Appln. No.10/656,710
Amendment & Response dated June 16, 2005
Reply to Office Action of: April 11, 2005

Amendments to the Drawings:

The attached replacement sheets of drawings include changes to Figs. 6, 8, 10, 17, and 19. These changes are shown in red on the attached annotated marked-up sheets and described in detail in the Remarks section below.

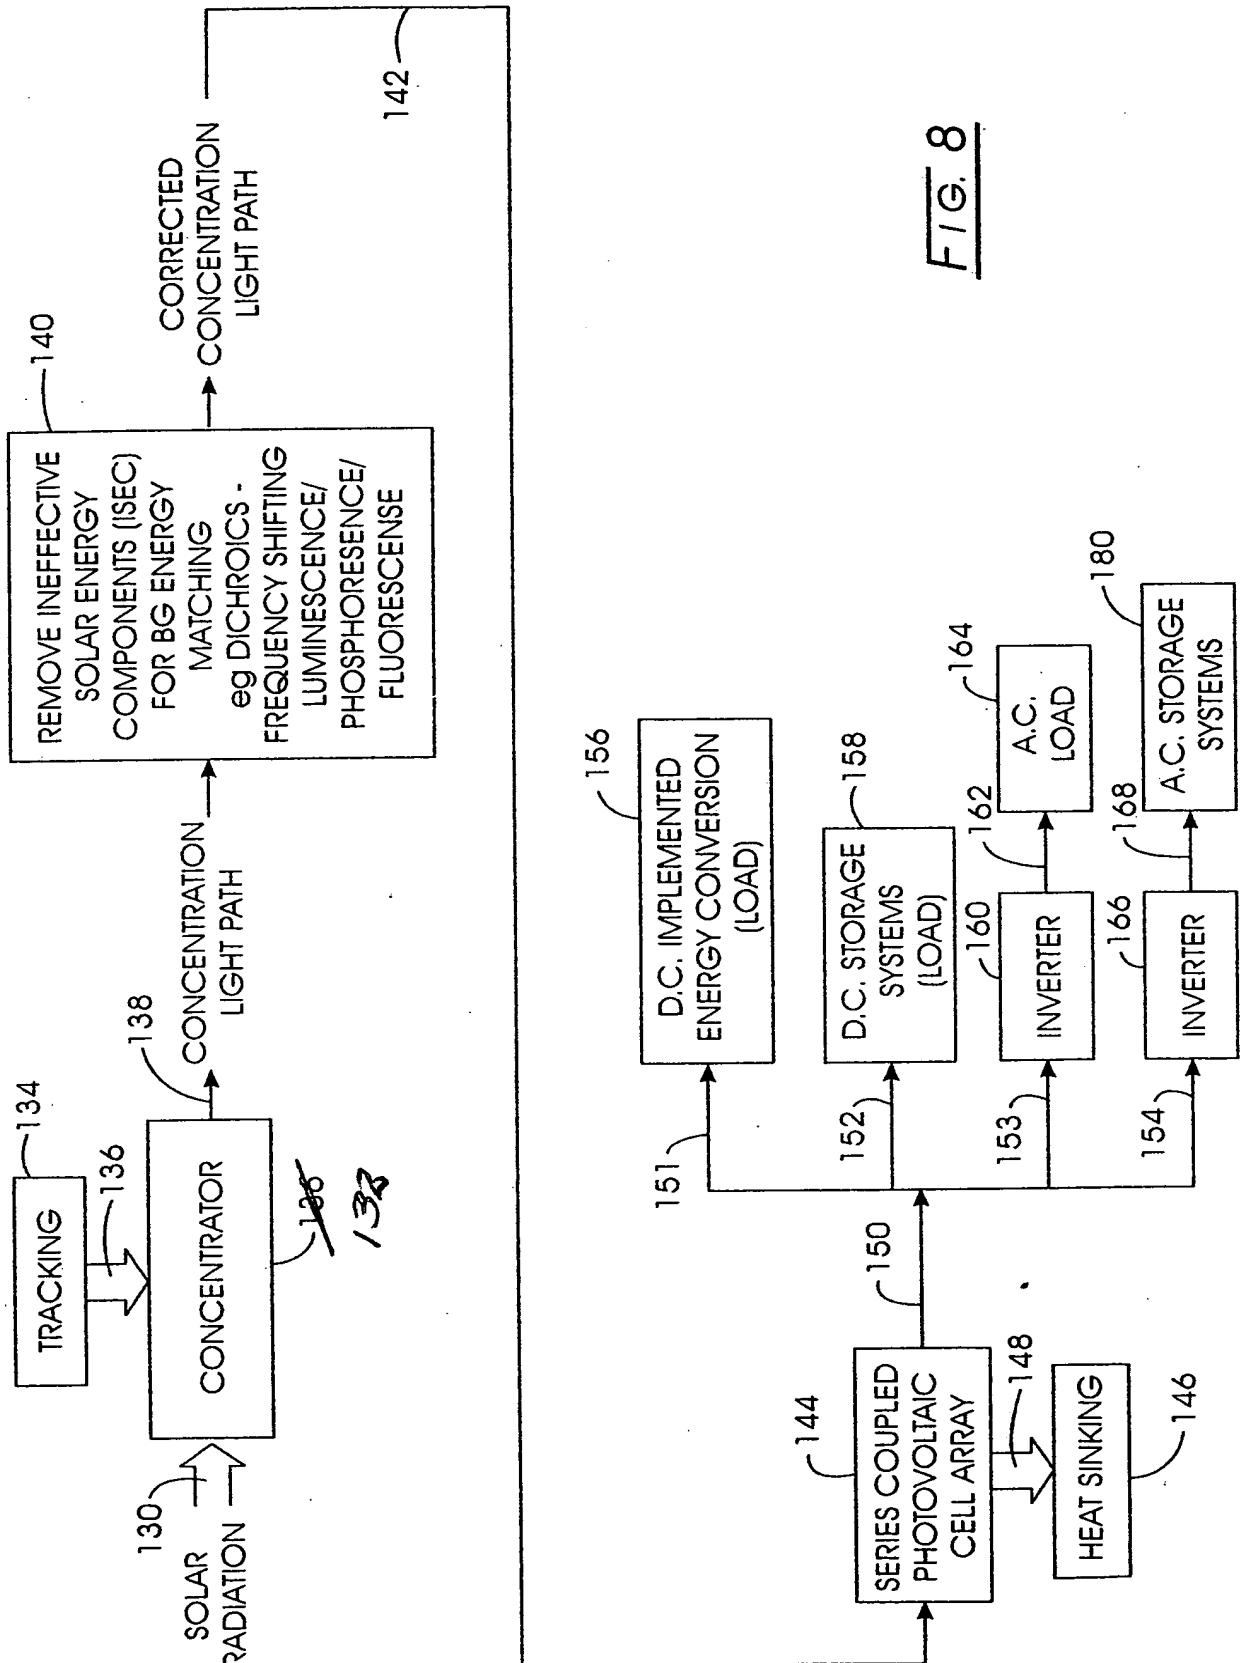
It is noted that the number "136" was used in two locations in Fig. 8. The number 136 representing a concentrator is changed to - - 132 - - in keeping with the specification at page 12, line 28. It is noted that the number 180 has been used to designate both an a.c. storage systems block in Fig. 8 and a mirror in Fig. 10. The number should be - - 170 - - in Fig. 8 as described at page 13, line 22. The Examiner has indicated that the number 240 of Fig. 11 is not mentioned in the description. With the instant amendment that number has been inserted after the word "load" at page 15, line 2. The Examiner has indicated that the number 532 in Fig. 19 is not mentioned in the description. That represents a numbering error inasmuch as Figs. 20 and 20A commence with the number 530. Accordingly, the numbers beginning at 522 and ending at 532 now are replaced with the number string 521-526. Appropriate amendments have been made to lines 30-34 of page 19. The Examiner has indicated that the number 78 is not mentioned at page 11 of the specification. The specification exhibits a typographical error here, line 15 at page 11 has been further amended to recite: "Hatched areas 72, 74 and 76 reveal very little effective...". That line was earlier amended to insert the term "device" after the term "photovoltaic". Spelling of the latter term has been corrected with the instant amendment. As indicated above, reference sign 132 has been added to Fig. 8 as it was mentioned at page 12, line 28. Similarly, number 170 has replaced the number 180 in Fig. 8. Further, the Examiner has indicated that the reference sign 200 identified at page 14 was not present in Fig. 10. That correction is made with the instant response.

FIG. 17

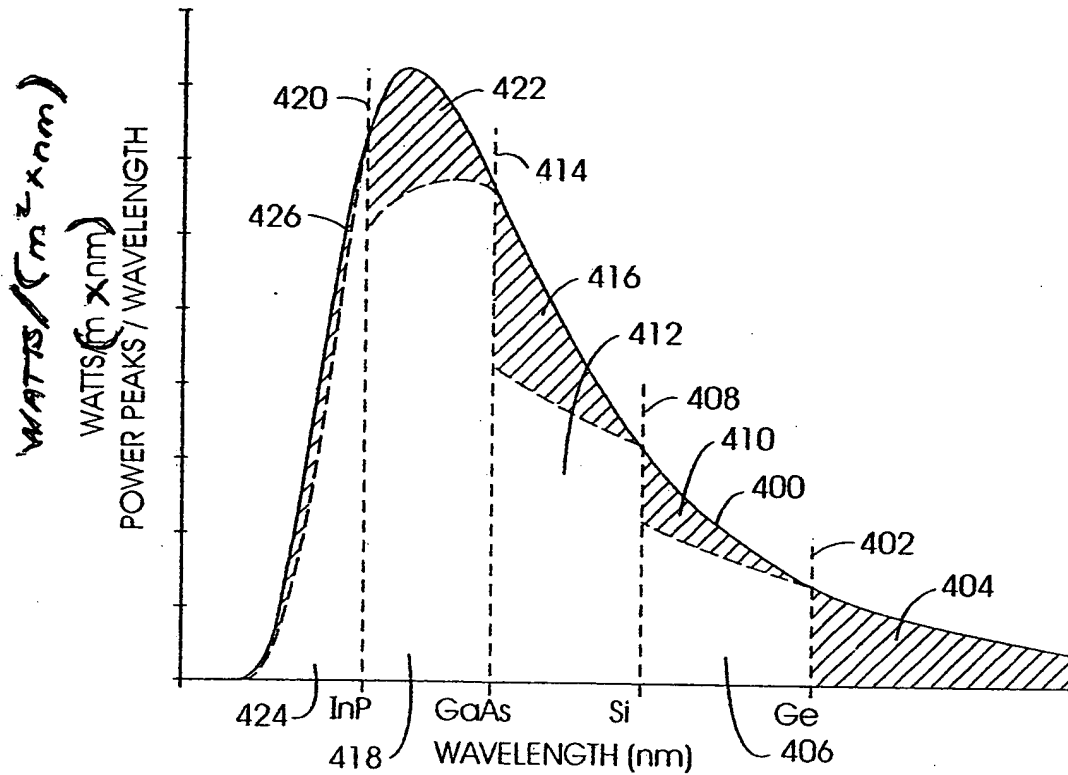
As an additional correction to the drawings, the ordinate labeling at Figs. 6 and 17 is corrected in keeping with the expression at line 30 of page 10.
